*A People Place, A Change of Pace*  
**SHELBURNE**  
ONTARIO, CANADA

**Report:** Financial Services 2021-02

**Subject:** **Connecting Link Contract Award**

TOWN OF SHELburne  
 CONNECTING LINKS - MAIN STREET EAST  
 RESURFACING PROJECT  
 PROPOSED RESURFACING PLAN  
 STA 0+000 TO STA 0+185

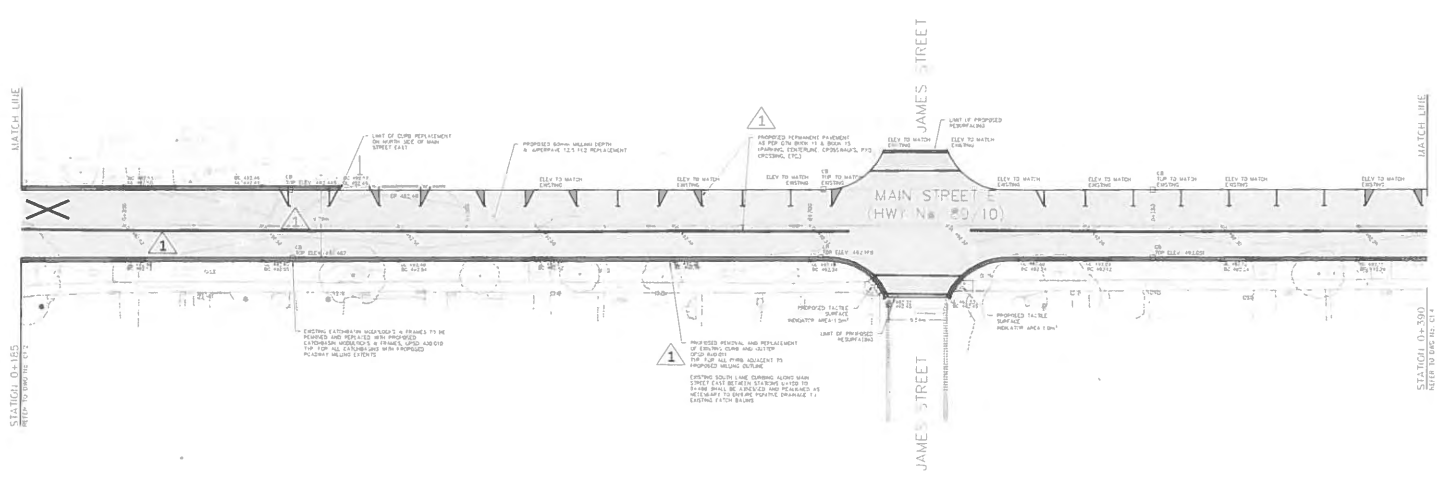
Question 12: *Could the Town please clarify what the diagonal hatching at the intersection of William and Main found on Drawing C1.2 represents?*

Question 14: *Clarify the note on Drawing C1.2 referring to Drawing C2.1.*

Response 12: Contractor to replace delineation as noted on Drawing C1.2.

Response 14: Contractors to refer to new Drawing C2.1 attached to this Addendum.
